Operation no. of operation texts and work units or standard texts
and flat rates:
30-4105

Engine 605.911

Engine 606.910

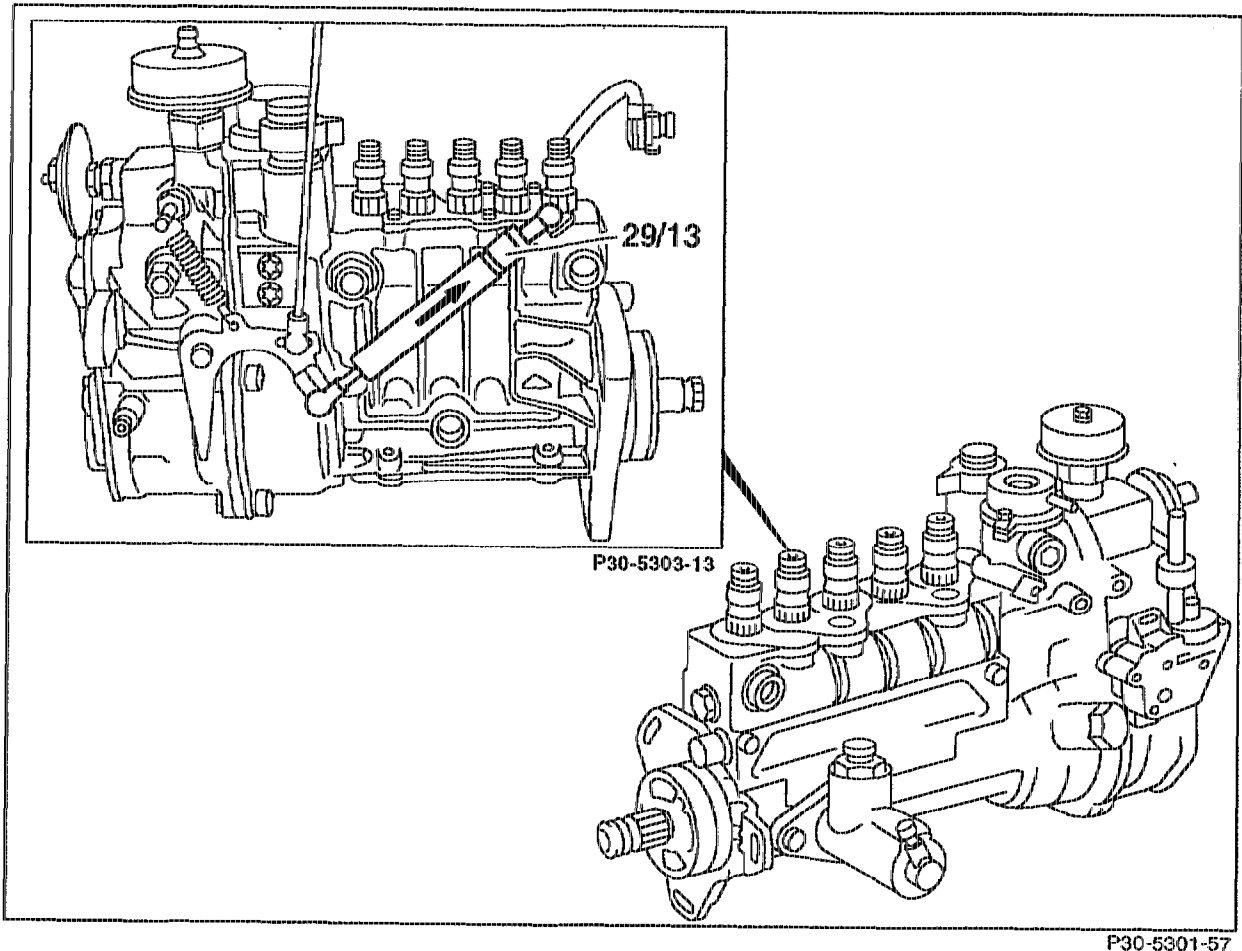
Ball sockets of accelerator control
damper (29/13) at injection pump press off, press on.

Pay attention to installation position (see arrow
on accelerator control damper).

Restoring spring modified. Strengthened restoring spring to ensure accelerator control damper moves back when engine idling.

Restoring spring at injection pump with increased spring force.

Production breakpoint: as of June 1993

Production breakpoint: as of September 1993
